Burlington Development Review Board

Development Review Board

Wednesday, March 11, 2026, 5:00 PM

To: Development Review Board
From: Mary O'Neil, AICP, Principal Planner
Date: March 11, 2026
RE: 633 Main Street; ZP-26-50

BICYCLE LONG TERM PARKING PLAN

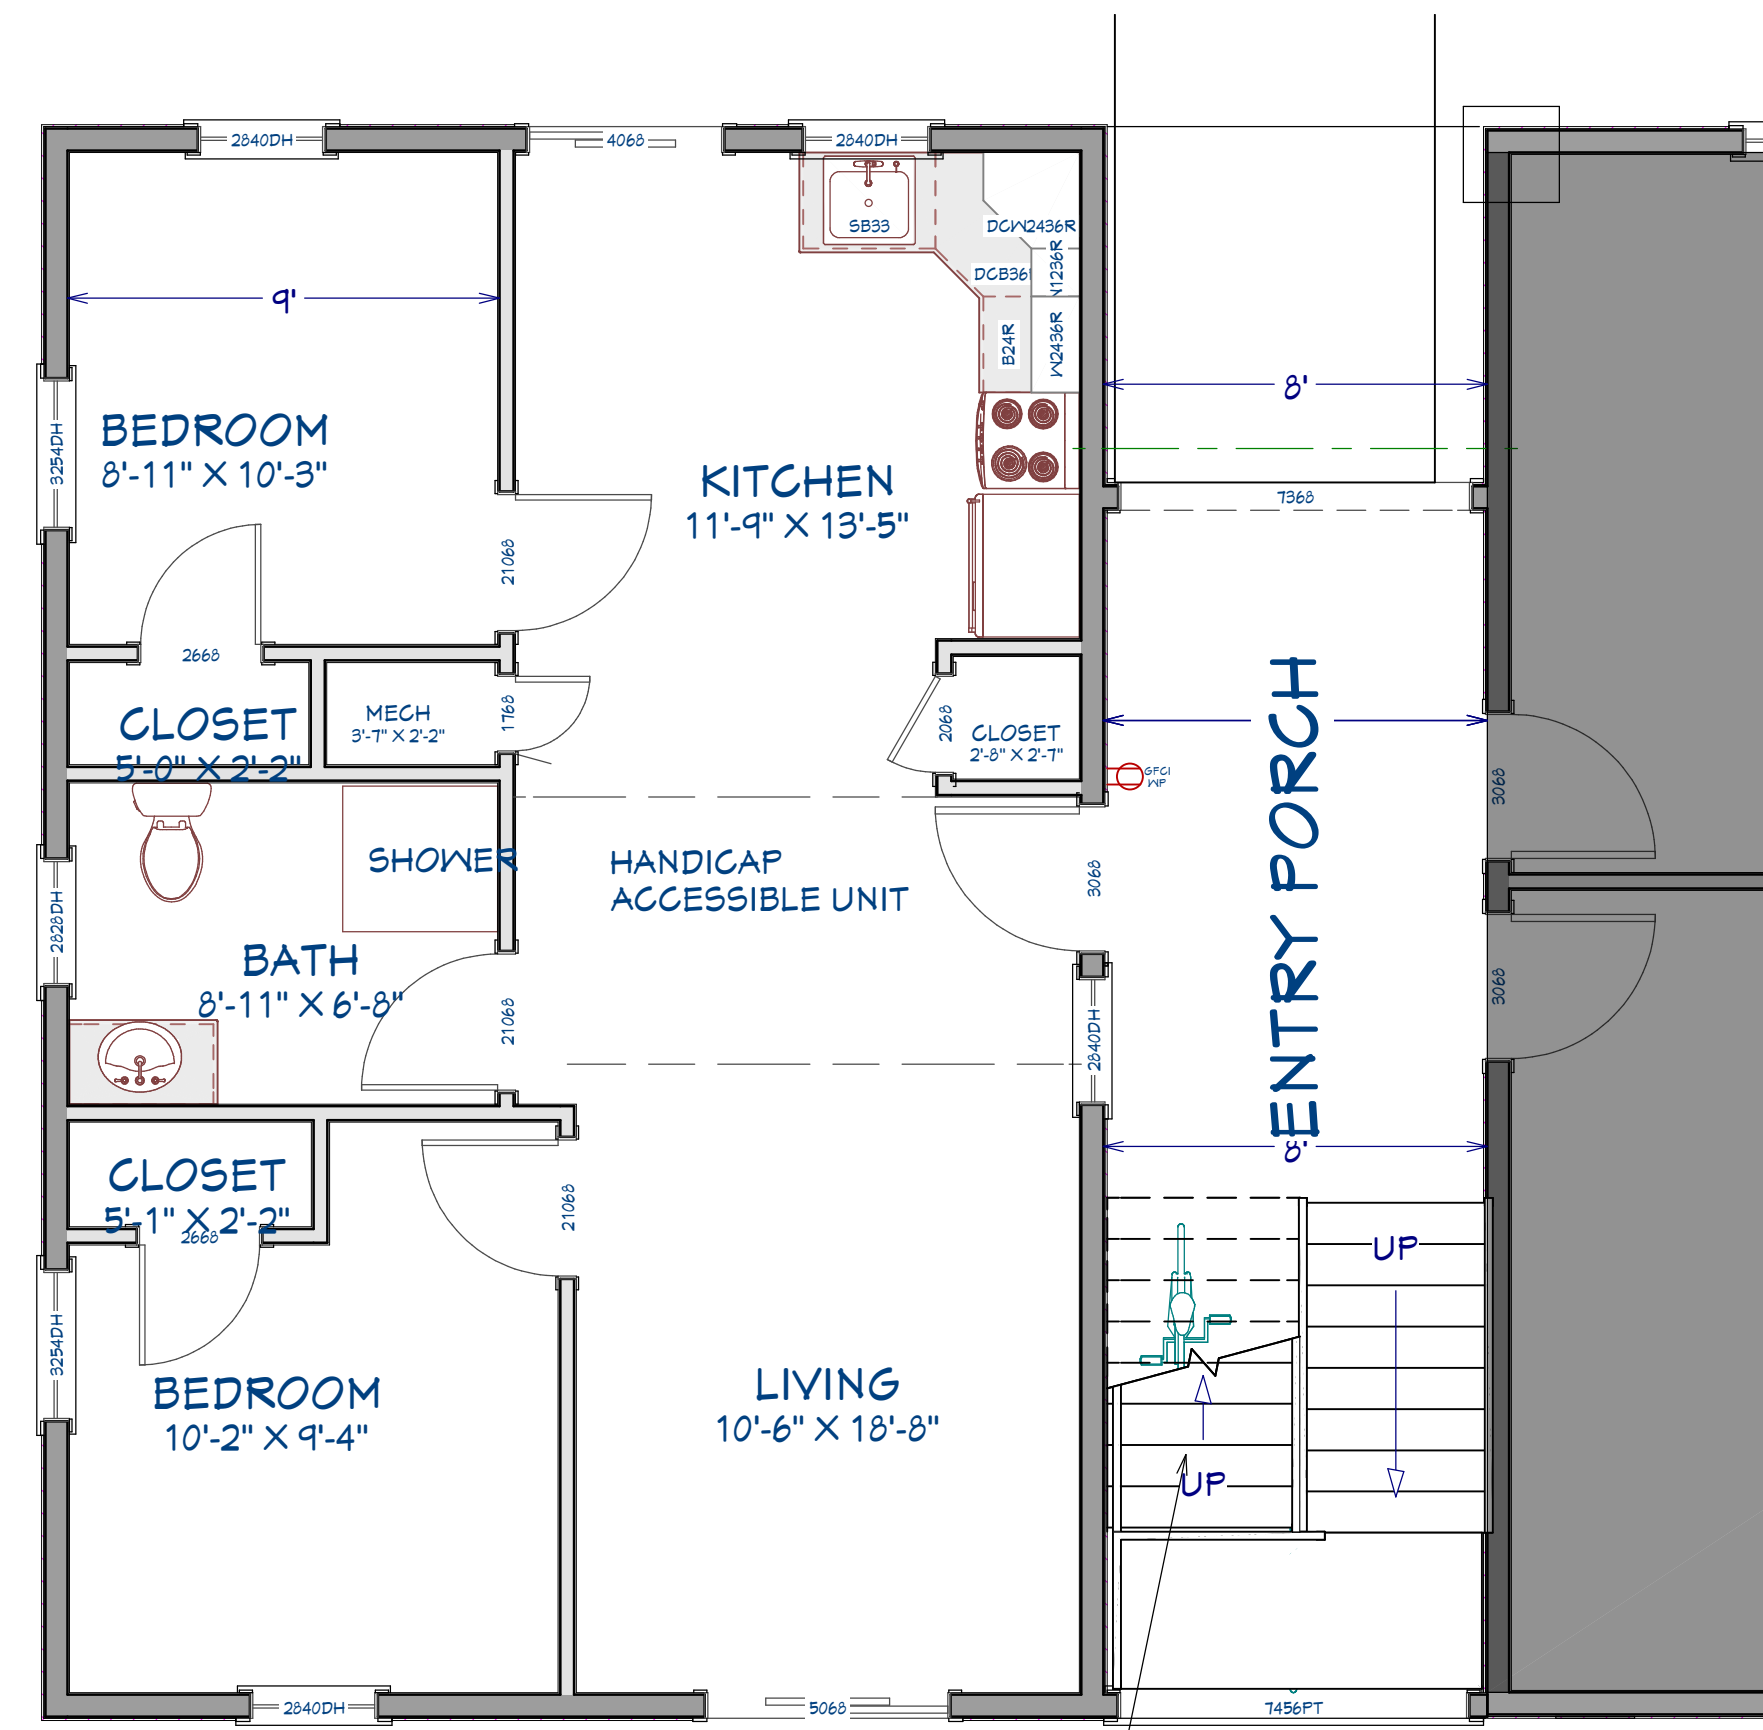
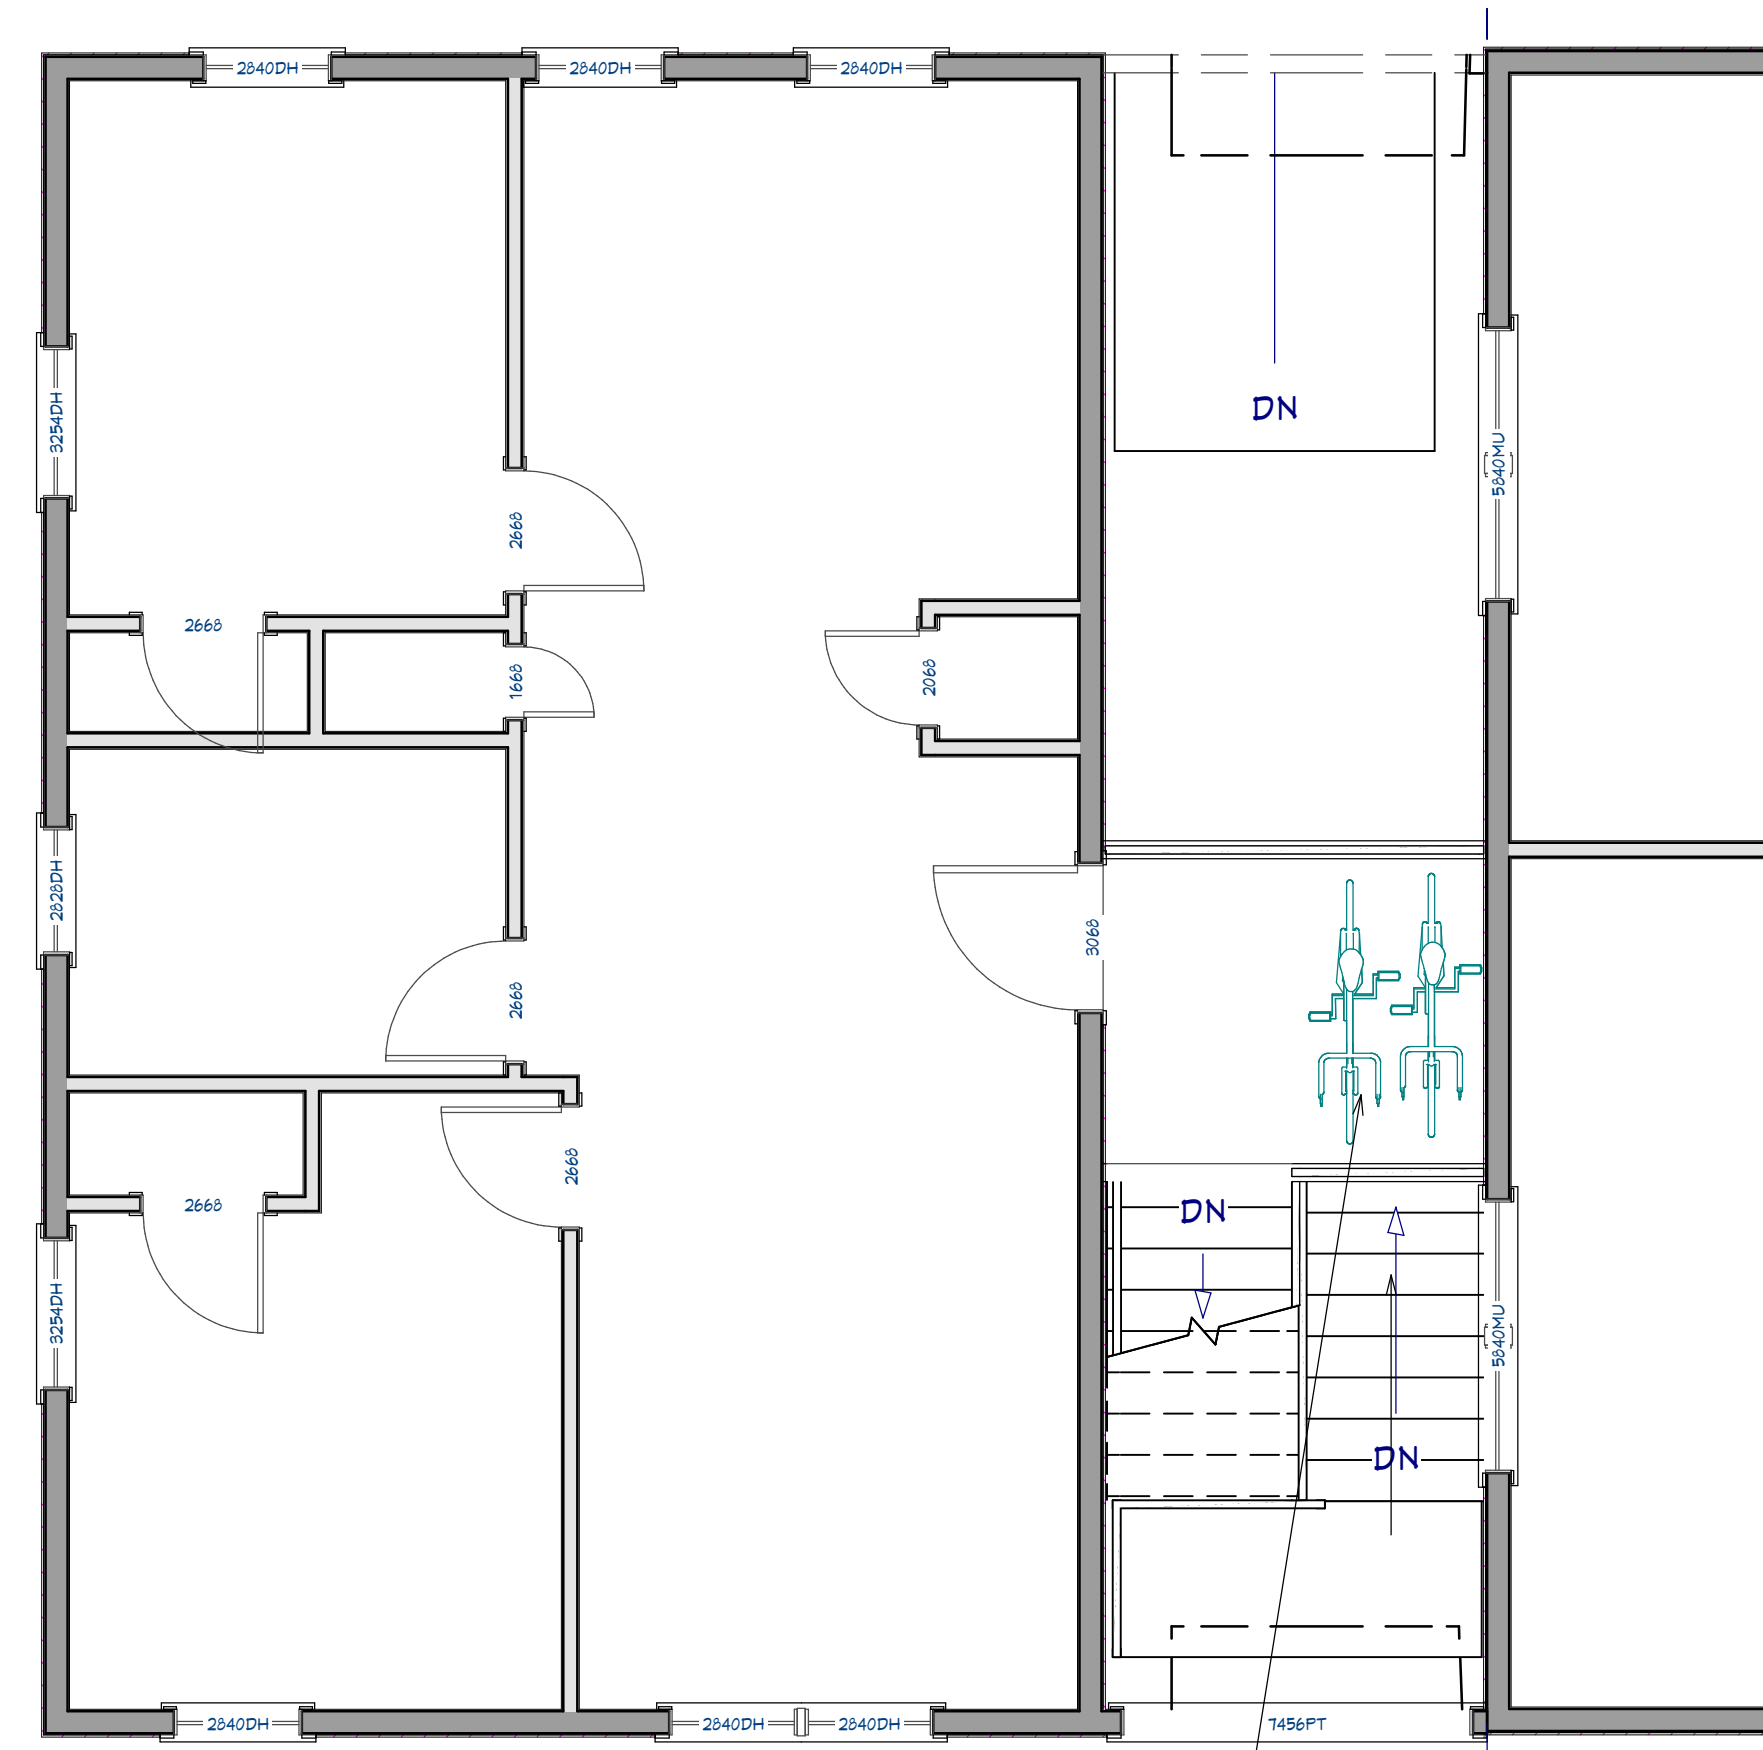
- The proposed development is consistent with the existing development pattern, building scale, and neighborhood character (planBTV, Planning to Sustain).
- The inclusion of dedicated secure bicycle storage will serve to benefit the connectivity of the proposed development to neighborhood-serving businesses and amenities (planBTV, Neighborhood Connectivity).
- The project will manage stormwater, in part, with newly created stormwater infiltration areas onsite (Comprehensive Plan, Natural Environment Action Plan). **(Affirmative finding)**
